BROWNS FERRY NUCLEAR PLANT (BFN) – UNITS 1, 2, AND 3 - TECHNICAL SPECIFICATIONS (TS) CHANGES TS-431 AND TS-418 – EXTENDED POWER UPRATE (EPU) – RESPONSE TO ROUND 19 REQUEST FOR ADDITIONAL INFORMATION (RAI) (TAC NOS. MD5262, MD5263, AND MD5264)

**TENNESSEE VALLEY AUTHORITY
BROWNS FERRY NUCLEAR PLANT (BFN)
UNITS 1, 2, AND 3**

RESPONSE TO ROUND 19 REQUEST FOR ADDITIONAL INFORMATION (RAI)

Figure EMCB-1: Unit 1 MSL Strain Gage Penetration

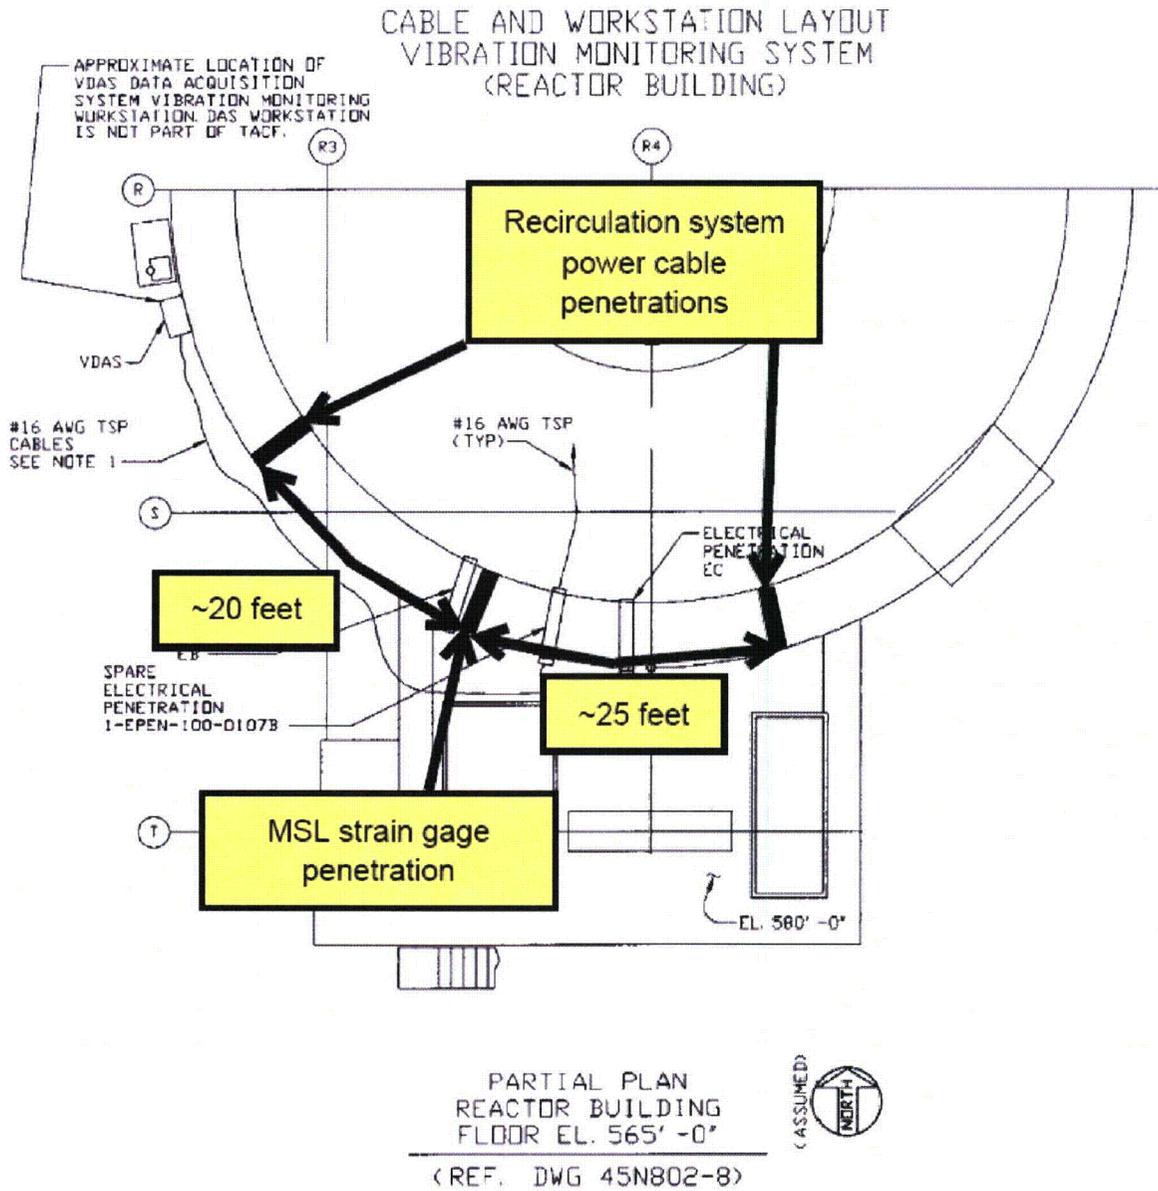
The increase in electrical noise in Unit 2 relative to Unit 1 is most likely caused by the close proximity of the electrical penetration for the MSL strain gage signals to the electrical power penetration for recirculation pump 2A relative to Unit 1. The MSL strain gage penetration for Unit 2 is adjacent to the recirculation pump 2A penetration, while the closest recirculation pump penetration to the Unit 1 strain gage penetration is approximately 20 feet (See Figures EMC.B-1 and 2).

Figure EMC.B.181-1a: Unit 1 Data MSL A

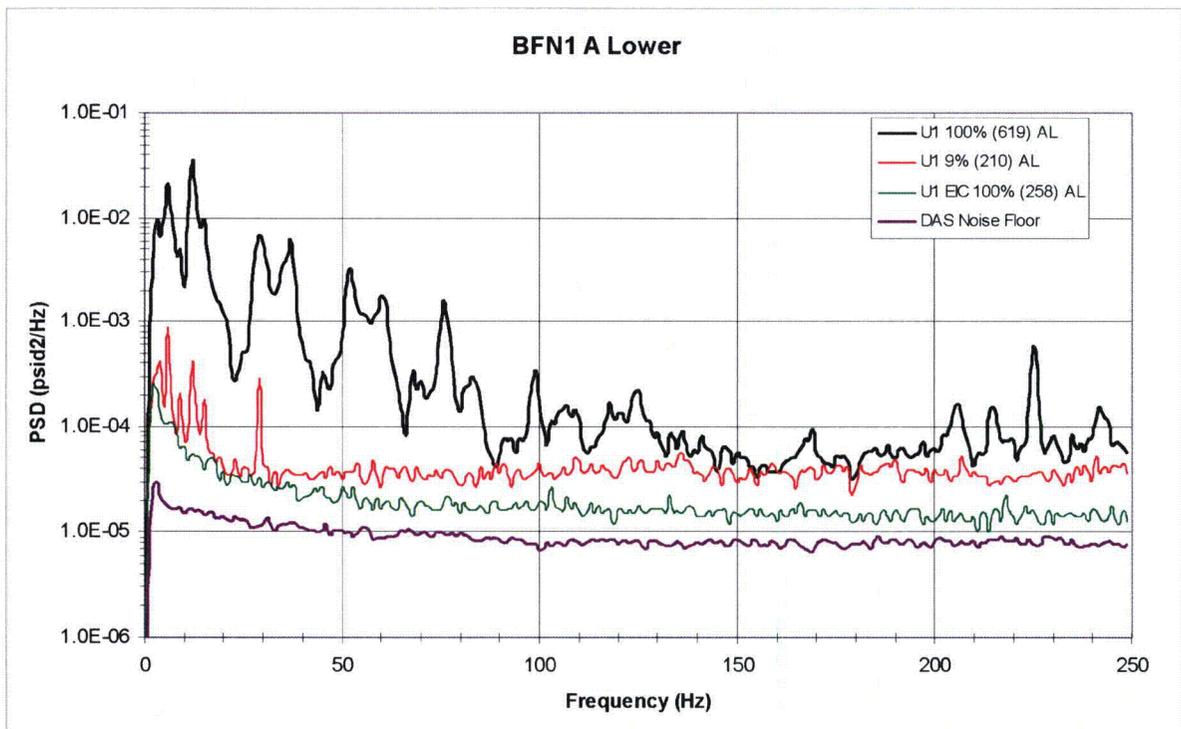
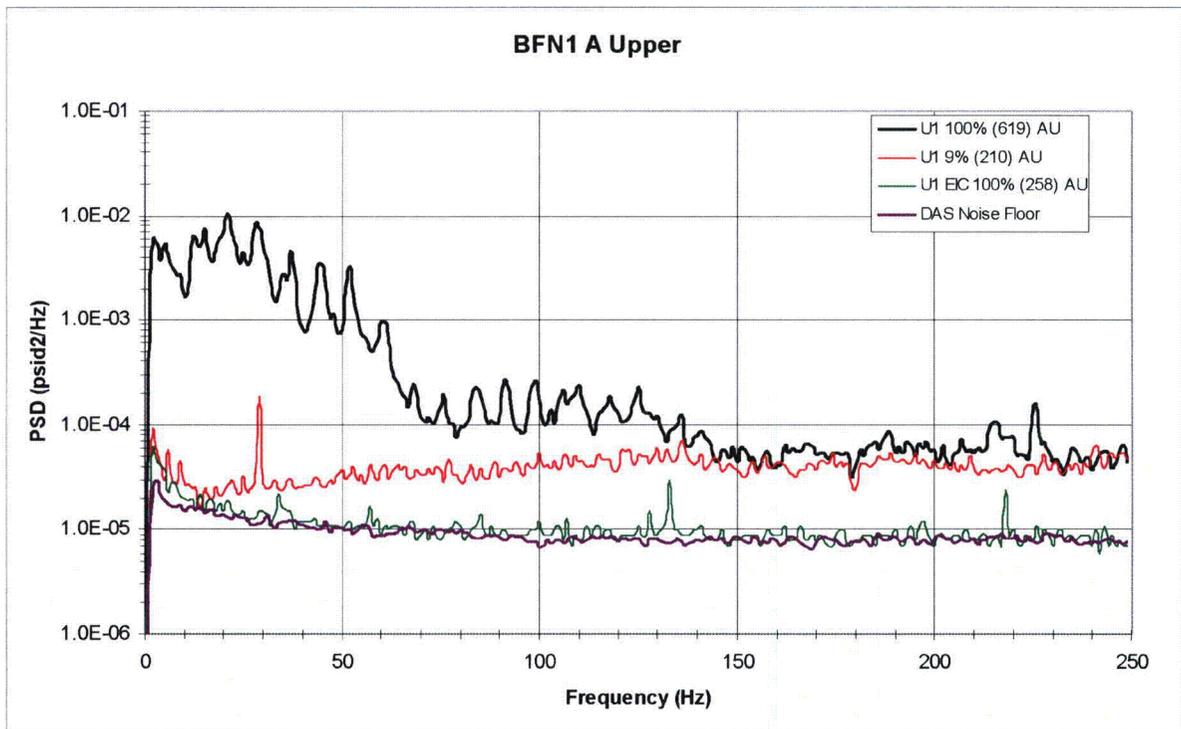
Provide data and analysis to confirm that the Unit 1 low-flow signals are actually due to plant background noise events, and not the noise floors of the sensors and data acquisition systems.

For example, EIC for BFN1 A Upper (top plot on Figure EMC.B.181-1a) shows little electrical noise above the DAS noise floor, indicating that the cables for that set of strain gages do not pick up significant plant noise. EIC for BFN1 A Lower (bottom plot on Figure EMC.B.181-1a) shows an observable increase over the DAS noise floor, indicating that a small amount of electrical interference is picked up by those cables across the frequency spectrum. Unit 2 EIC for BFN2 C Upper (top plot on Figure EMC.B.147-1c) shows electrical noise above the DAS noise floor similar to Unit 1 below 80 Hz but increases with frequency above 80 Hz.

A DAS of the same type used at BFN was set up in a laboratory environment with cable and strain gages connected for the purpose of measuring the noise floor of the equipment itself. Figures EMCB.181-1a through 1e are PSD plots of the equipment noise floor as measured in the laboratory, the Unit 1 LF (9% power) data and the Unit 1 CLTP data. It can be seen that the plant noise data is well above the noise floor of the DAS and, therefore, is a valid measurement.

Figures EMCB.181-1a through 1d are PSD plots of Unit 1 signals which illustrate example signal magnitudes. The signals were filtered at the following frequencies to eliminate known noise sources.

Figure EMCB.183-1a: Accumulative alternating stress intensity curves for node 88059

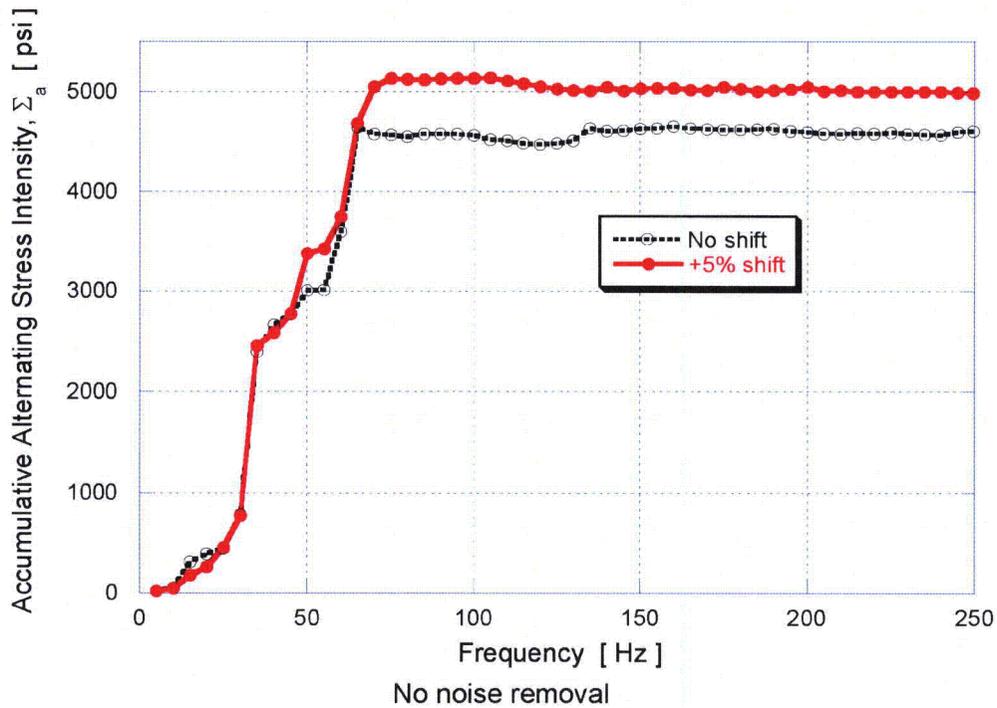
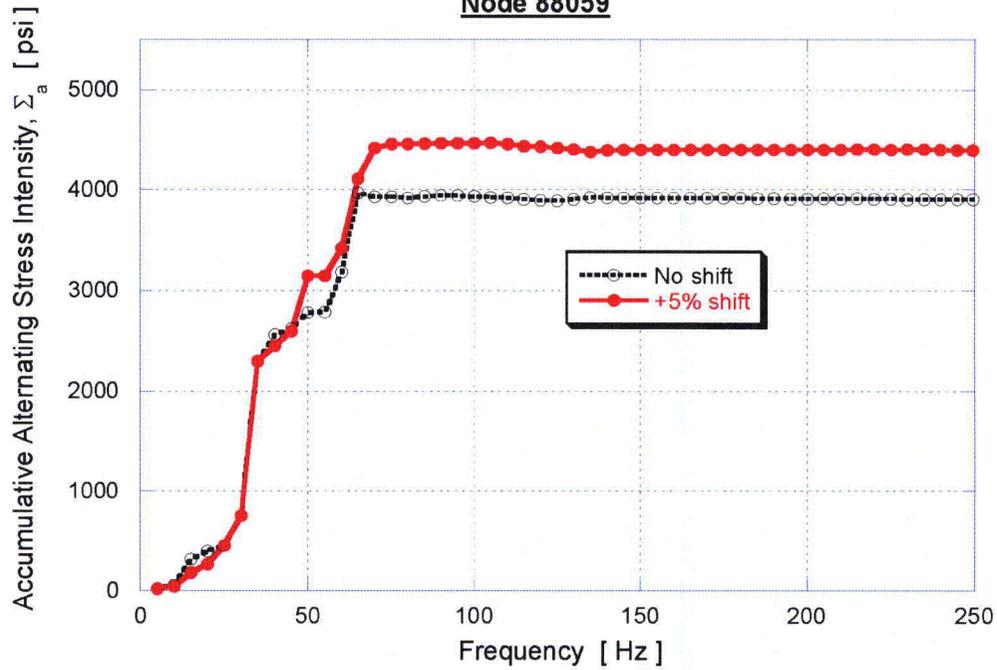
The accumulated stress plots presented in response to RAI EMCB 170/138 show that the alternating stress amplitude increases little beyond 100 Hz. Please explain this observation. Provide similar stress plots when unfiltered MSL signals are used for the stress analysis of Unit 1 dryer. Please explain the differences between the plots for filtered and unfiltered signals.

Figures EMCB.183-1a through j shows the accumulative stress intensities without noise removal. To facilitate comparison, the accumulative alternating stress intensities presented in the response to RAI EMCB 170/138 using noise removal algorithm (i) above are also shown. As before, the accumulative alternating stress intensity, $\Sigma_a(f)$, is defined as the alternating stress computed when zeroing all stress harmonics for frequencies above f . It is computed in 5 Hz increments as explained in the response to RAI EMCB 170/138.

In all cases, with or without noise removal, the dominant increases in the accumulative alternating stress intensity occur below 100 Hz. With noise left in, node 104539 exhibits the strongest increase above 100 Hz, though still less than the rise below 100 Hz. At the worst case frequency shift (+10%) for this case, the increase in alternating stress intensity between 0 to 100 Hz is 3560 psi. The remaining increase above 100 Hz is 604 psi, or less than 17% of the 0-100 Hz rise. The other node with a significant increase above 100 Hz is node 102407 which shows a jump at approximately 120 Hz. The total increase for this node (noise left in and the worst case frequency shift of +2.5%) above 100 Hz is 703 psi which is 14% of the 0-100 Hz stress rise (4955 psi).

Figure EMCB.147-1a: Unit 2 Data MSL A

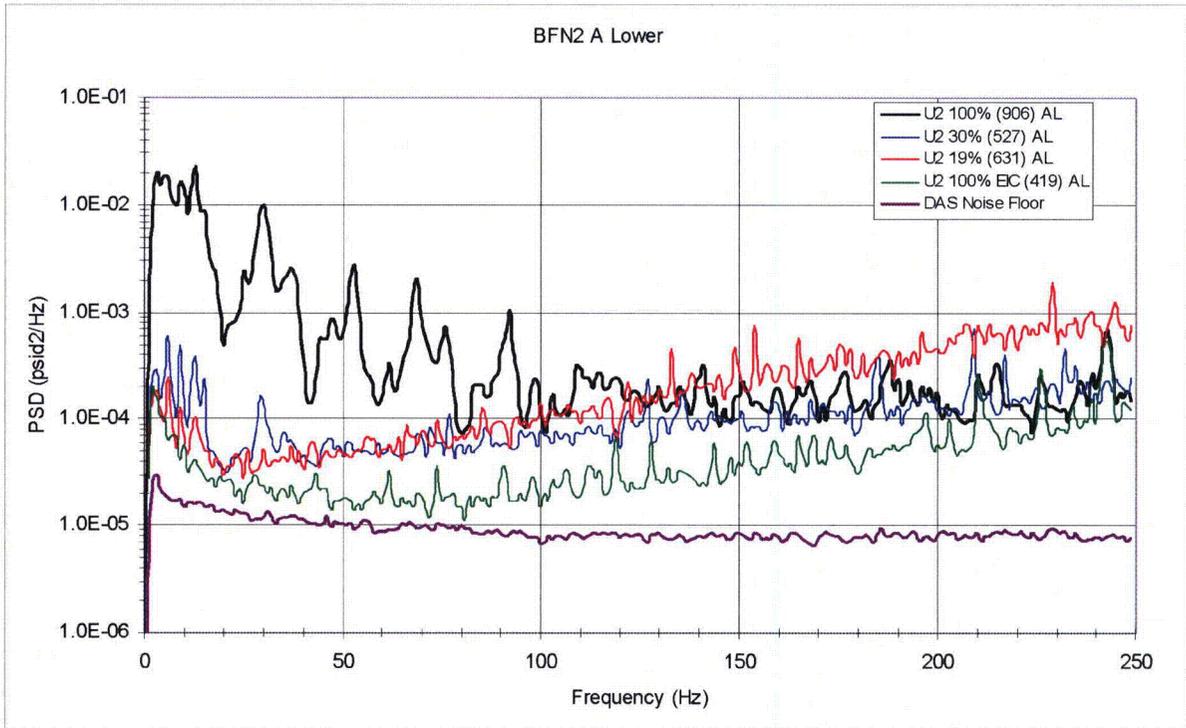
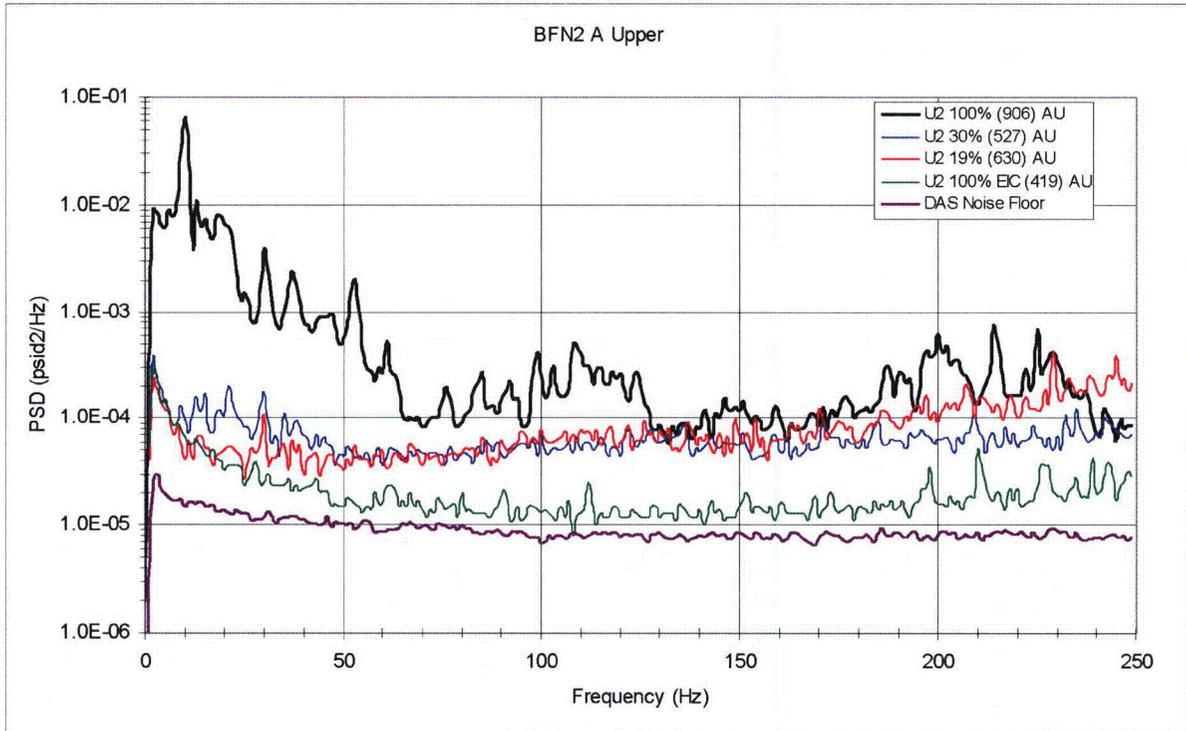
Provide analysis and plots for Unit 2 similar to those provided for Unit 1 in response to RAI EMCB.172. Provide an explanation why the 19 percent power data shown in Figures 3.2 through 3.5 in CDI Report No. 08-05P, *Acoustic and Low Frequency Hydrodynamic Loads at CLTP Power Level on Browns Ferry Nuclear Unit 2 Steam Dryer to 250 Hz*, are higher than the data at CLTP for frequencies above about 120 Hz. Provide justification for removing any signal from the Unit 2 CLTP source strengths without reliable background noise signals. TVA should include stress and stress ratio tables in CDI Report 08-16P, *Stress Assessments of Browns Ferry Nuclear Unit 2 Steam Dryer with Tie Bar and Hood Modifications*, using unfiltered MSL signals.

Figures EMCB.147-1a through 1d show PSD plots of available Unit 2 data including 19% power, 30% power, CLTP and an EIC signal taken at CLTP conditions. It can be seen from the EIC signal that Unit 2 data contains electrical noise that increases with frequency above 80 Hz. The most likely source of this noise is the VFD providing power to the 2A recirculation pump due to the close proximity of the strain gage signal penetrations to the pump power penetrations. The recirculation pumps are powered by VFDs which produce AC waveforms using multilevel pulse width modulation. Therefore, strong coupling of the signal may be expected to result in harmonic noise. By comparing the 19% power, 30% power and CLTP signals, it can also be seen that as power increases from 19% to 30%, the amplitude above 150 Hz decreases to that of the CLTP value. Analysis of Unit 1 data (see Figures EMCB.181-1a through 1d) shows that the amplitude of MSL strain gage data does not change significantly with steam flow and power level above 150 Hz. The most likely cause for the behavior of Unit 2 data is a decrease in the 150 - 250 Hz spectral content of noise contribution from the Unit 2 VFD as recirculation pump speed is increased from minimum speed (~16 Hz) at 19% power to ~ 25 Hz at 30% power.

Figures EMCB.147-1a through 1d are PSD plots of Unit 2 signals which illustrate example signal magnitudes. The signals were filtered at the following frequencies to eliminate known noise sources.

Figure EMCB.187-1: Stiffener Shell Submodel and Full 3D Shell Model Stress Profile Comparison

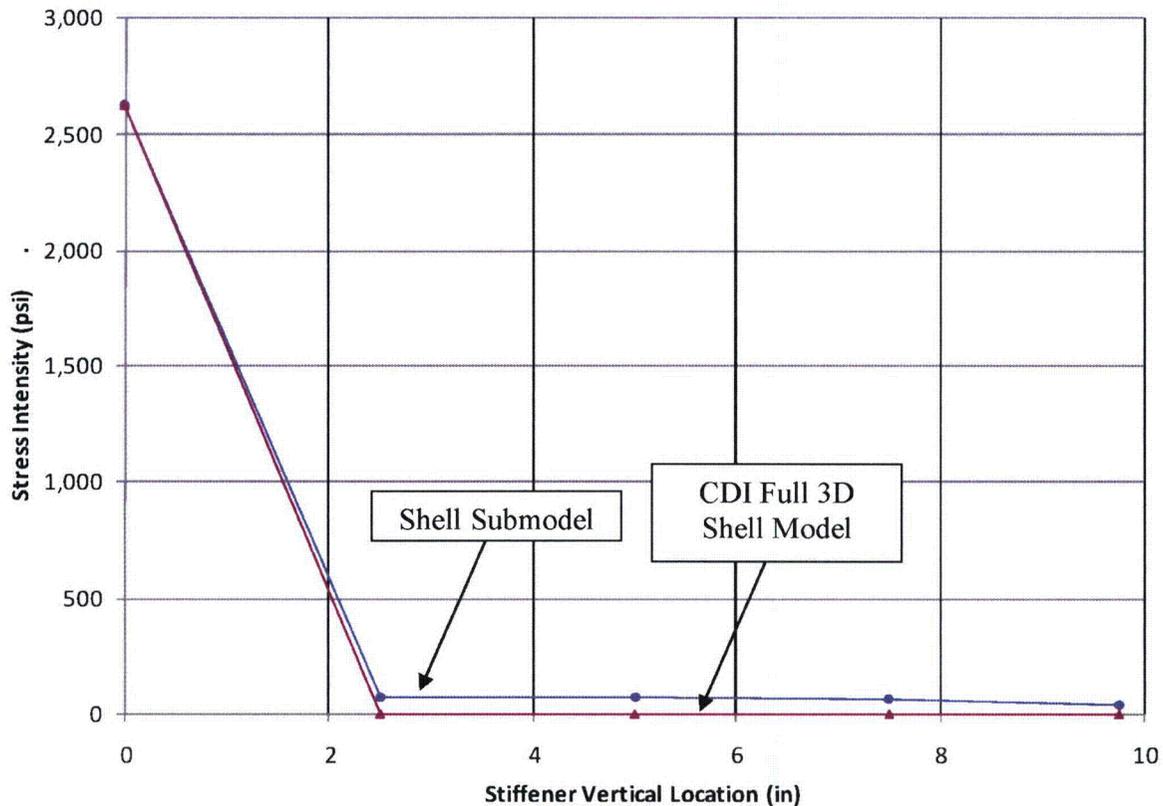
Figure 4.1 of the SIA calculations shows that 1,000 lb force is applied to the stiffener. Please explain why no loads are applied to Edges A, B and C? TVA is requested to provide the final applied load to the sub-model and a comparison of the resulting sub-model stress profile and the full model stress profile.

In the final iteration, the applied load is 267.2 lbs, evenly distributed over 1.75 inches of the stiffener height. Figure 4.1 of the SIA calculation shows the applied load 1,000 lb, which is the initial load used at the start of iteration. The actual load that corresponds to the full 3D shell model stress is 267.2 lbs.

The comparison of the stress profile in the shell submodel and the stress profile of the CDI full 3D shell model is shown in the Figure EMCB.187-1.

The stress profile comparison is focused on the 5 nodes closest to the location of interest, which is located at the bottom of the stiffener (i.e., at 0 inch vertical location). Nodes further away from the location of interest have diminished and insignificant influence on the maximum stress at the bottom. As the stress drops off very quickly away from the highest stress location located at the bottom of the stiffener, it is considered that the stress profile comparison up to the first 5 nodes is sufficient.

Figure EMCB.189-1: Drain Channel Imposed Displacements

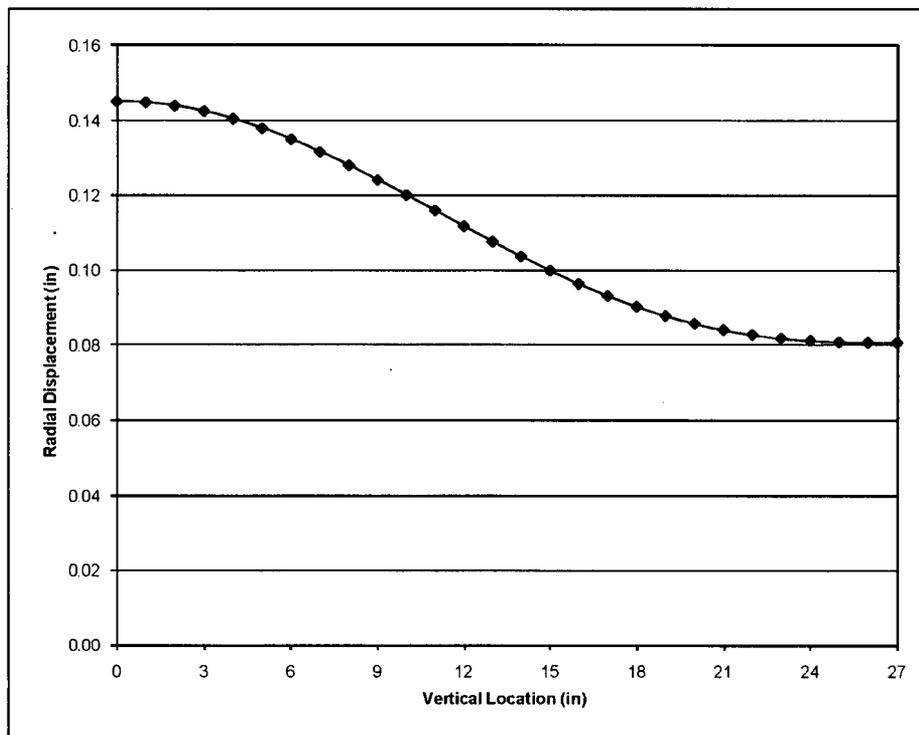
Provide the final magnitude of imposed displacement along with the location and a comparison of the resulting sub-model stress profile and the full model stress profile.

A plot of the final imposed drain channel/skirt displacements is provided in Figure EMCB.189-1.

The imposed displacements are in the outward radial direction along the vertical Line C (see Figure EMCB.188-1). The maximum magnitude of displacement is 0.145 inch at the bottom, reducing to 0.08 inch at the top of the modeled drain channel. Figure EMCB.189-2 shows the comparison of the stress profile.
